#### Zoning & Planning Committee Report

# City of Newton In City Council

#### Thursday, July 9, 2020

#88-20 Discussion and review relative to the draft Zoning Ordinance

#### 35 FAIRLEE ROAD, SR2-R2

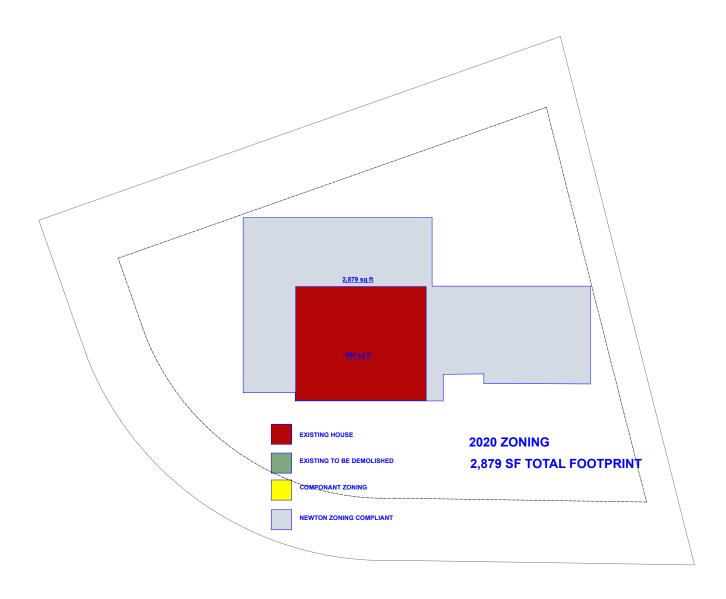
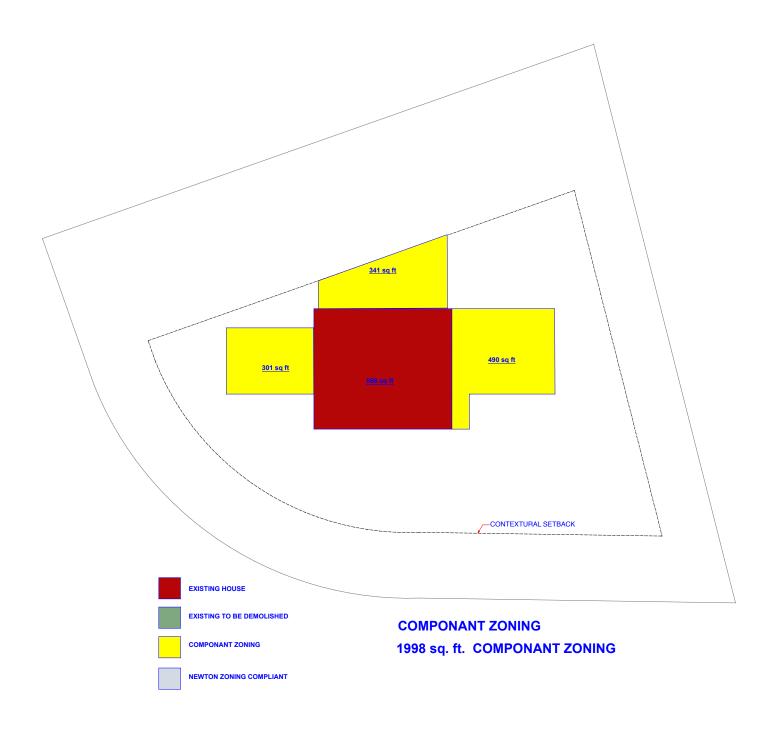
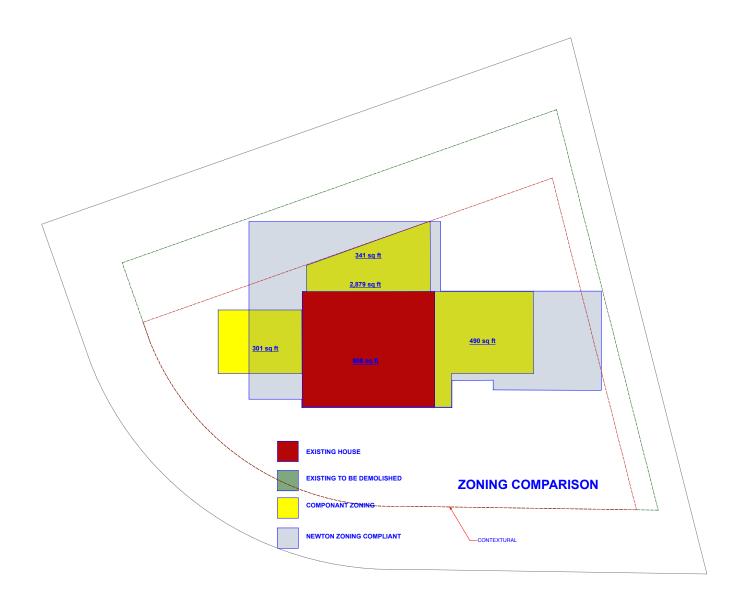
35 Fairlee Road: This property is currently under renovation. The house sits on an SR2 lot which would be zoned R2 under the proposed zoning. Mr. Sangiolo presented the floor plan of the existing home, showing portions to be demolished. A site plan of the project as approved at 2,879 sq. ft. shows additions to be constructed within the current setbacks which therefore require no special permit. A second site plan showed how the house would have to be modified to comply with the proposed zoning, which he believes could only consist of three separate additions and total 1,998 square feet.

**A:** The current code is preferable because it lacks the 30-foot rear setback requirement. The proposed code does not apply well to irregular lots such as 35 Fairlee Road.

**Q:** Rooms do not normally have the trapezoid shape shown at 35 Fairlee in order to meet the proposed 30-foot setback requirement. This condition could make a hardship for people who want to expand the rear of their house. In this circumstance, how could it have worked? Is there a better setback than 30 feet?

**A:** Additions could be made on other sections than the rear of the house or the setback could be made closer to 20 feet.

# 659 CHESTNUT STREET SR2, R1

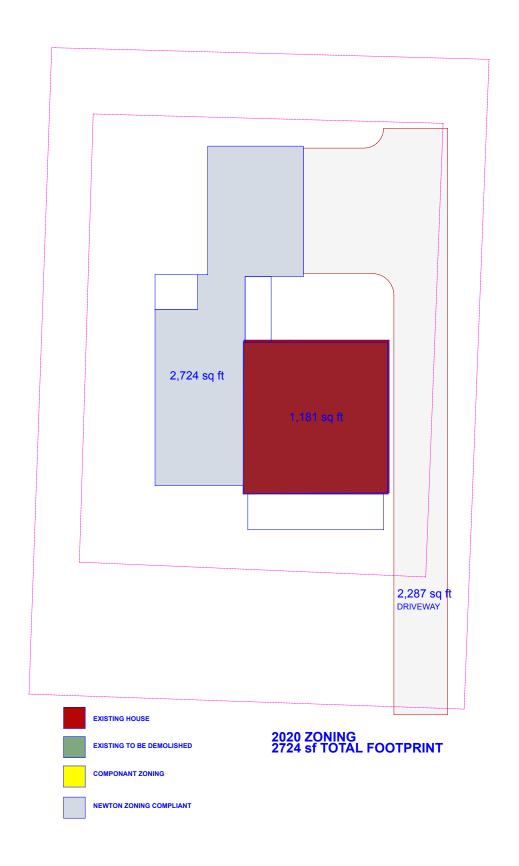
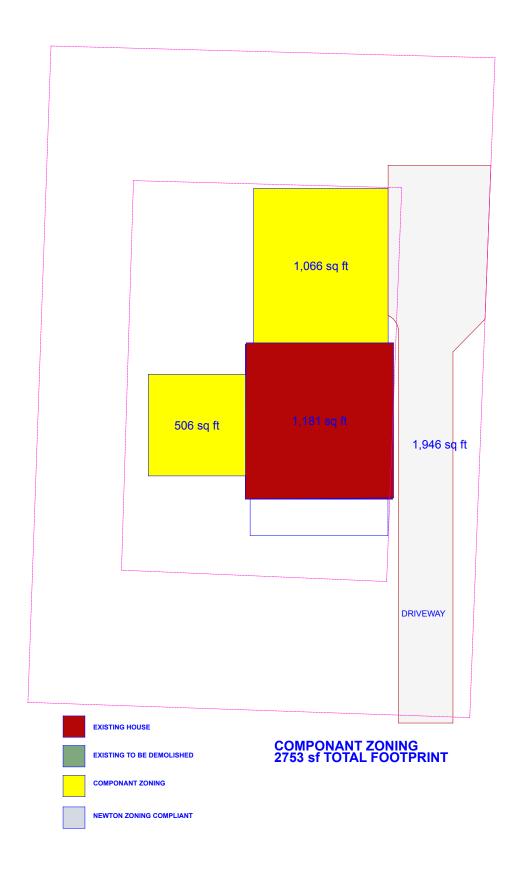
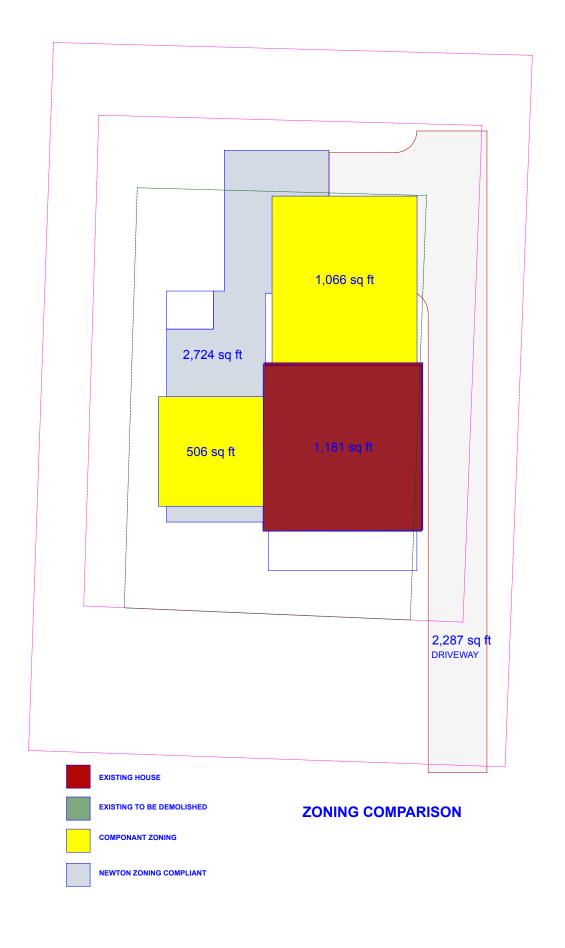
659 Chestnut Street: As built, the house is 2,724 square feet. Under the proposed zoning that allows adding components, Mr. Sangiolo would have been able to design for up to 2,753 square feet, though he believes he would have been unable to connect all parts of the additions due to the proposed larger setback restrictions.

**A:** These projects could have been made viable, but they are better under the current ordinance. For example, the project at 659 Chestnut Street would not have been able to fit the addition within the proposed larger setbacks as one piece, requiring it to be split into two. The component zoning does not work well with rear additions on irregular lots. These lots may sometimes require a variance under the proposed ordinance.

# 12 Irvington Street, Waban

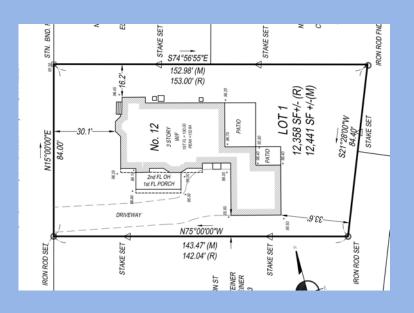
mudroom. The back of the house was pushed out to increase the size of the kitchen and the porch was also rebuilt. Mr. Powdermaker noted that this project worked well under the current zoning. He noted that under the proposed ordinance, the building would not have complied with lot coverage and side setbacks. He explained that if he reoriented the garage to be side facing to remain within the proposed setbacks, it would have taken up too much space on the lot in the backyard.

- Lot Coverage calculated at 31%, 25% allowed (patio not included in calc.)
- Non-conforming exiting setbacks 8.4'
- Redesign options would increase lot coverage, decrease usable open space, decrease value.

- Building Component approach not a burden
- Change in Lot Coverage creates a burden
  - Patios vs. Decks vs. Lawn
  - People have more cars today
- Setback change creates burden
  - Many existing properties do not comply as is

# 63 Bowdoin Street, Newton Highlands

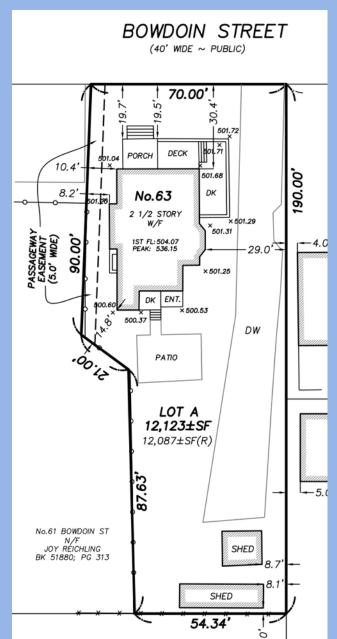
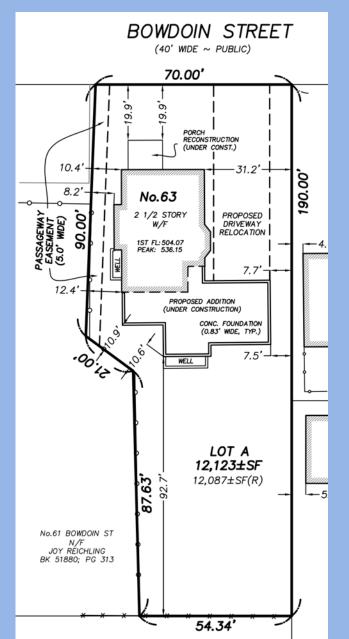
63 Bowdoin Street: Mr. Powdermaker stated that this was another house he refurbished on an irregular lot. In addition to extensive work inside the house, two rear-sheds were torn down which allowed him to attach a garage with rooms above and to shorten the driveway. Mr. Powdermaker said that under the proposed ordinance, the irregularity of the lot would mean that the rear garage would have to be made side facing, which would take up too much backyard and lot coverage. If the proposed zoning ordinance prevented the construction of a two-car garage, this would have reduced the value of the house. He stated that under the proposed zoning, this house would likely have been subject to a teardown.

- Component approach not a burden
- Change to Lot Coverage is a burden
  - Patios vs. Decks vs. Lawn
- Setback change creates burden
  - Many existing properties do not comply as is
- We could not have paid what we did to purchase this house under the new zoning
  - Impact on family that inherited the house?
- What do buyers want in an expensive house?
- Incentives to tear-down increased

- Lot Coverage at 31.8%, 30% allowed, (Patio not designed at outset, not included in calculations)
- Setback restriction & viable garage
  - We built 21' wide (external)
- Redesign options detrimental to value, to useable open space, would increase lot coverage, decrease usable open space.

#### **ADUs-Internal Accessory Apartments**

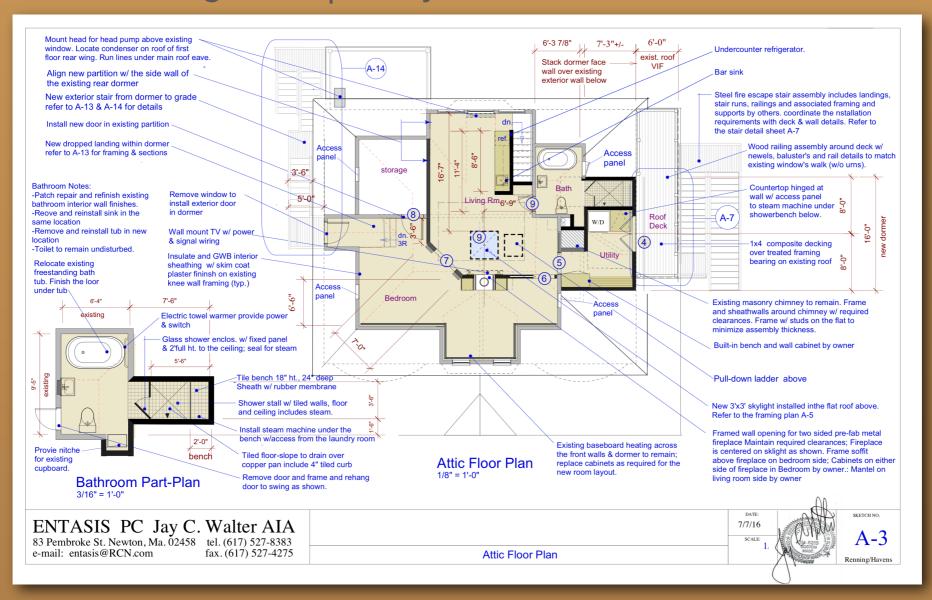
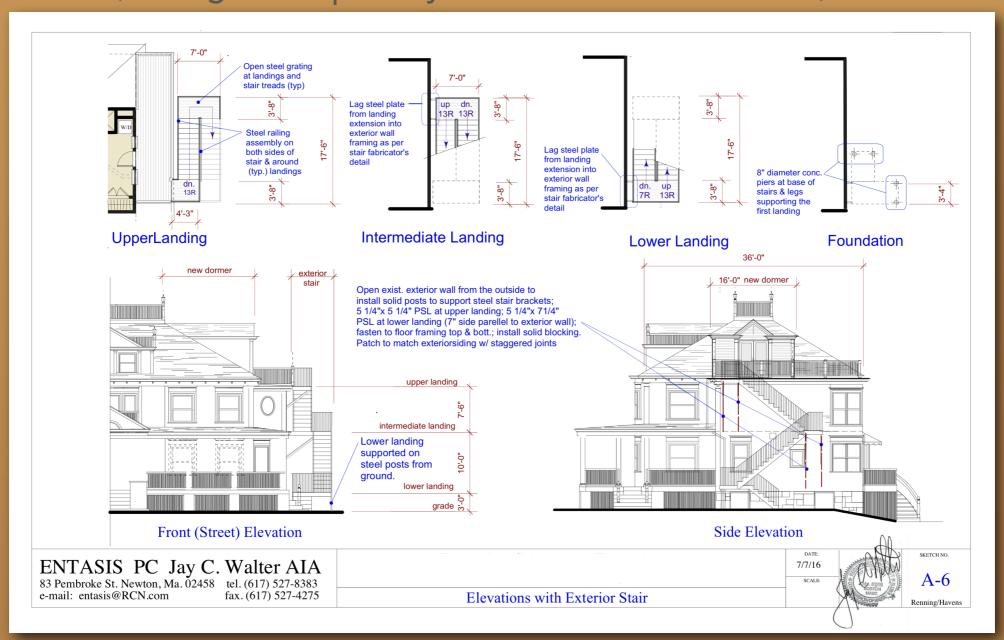
Why do we care how much of the interior of a house is an accessory apartment? (as long as the primary household is at least 51%)

Type 'A' House 6000 sf : Max allowable area by right- 1000 sf = 16%

recommendation: Do away with area limitations (as long as the primary household is larger)

## **ADUs- Detached Accessory Apartment**

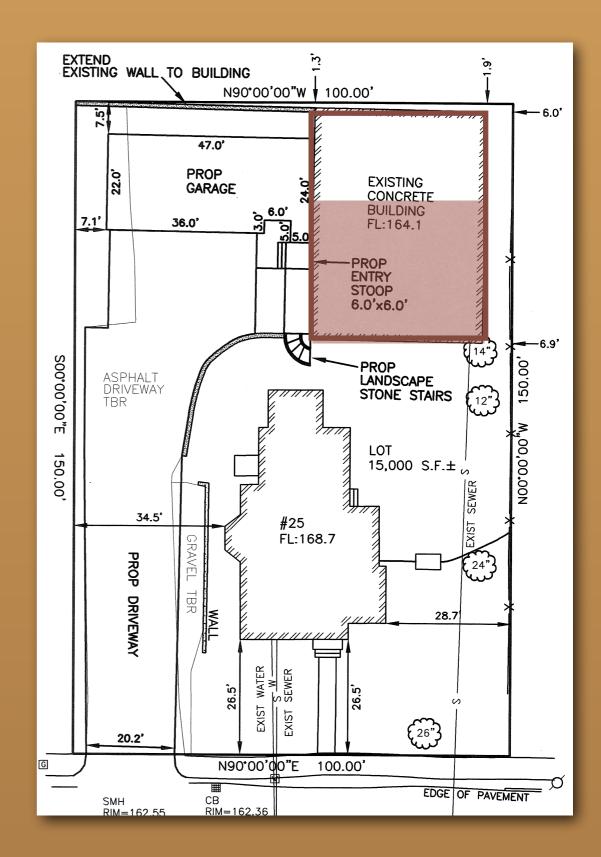
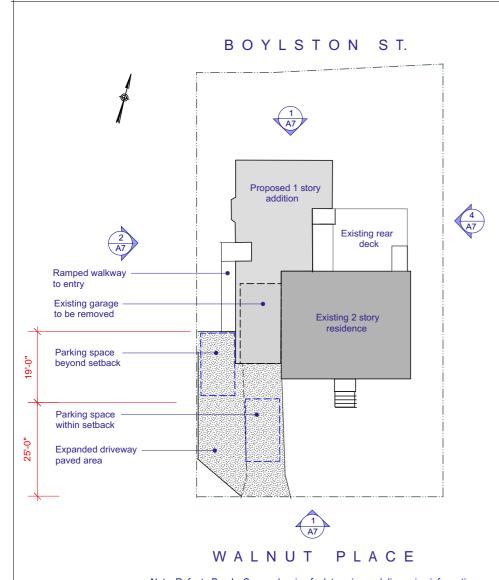
Why do we limit the size of detached accessory apartment?

Allow the full build-out of existing accessory structures like houses, barns or garages within the limits of the existing structure.
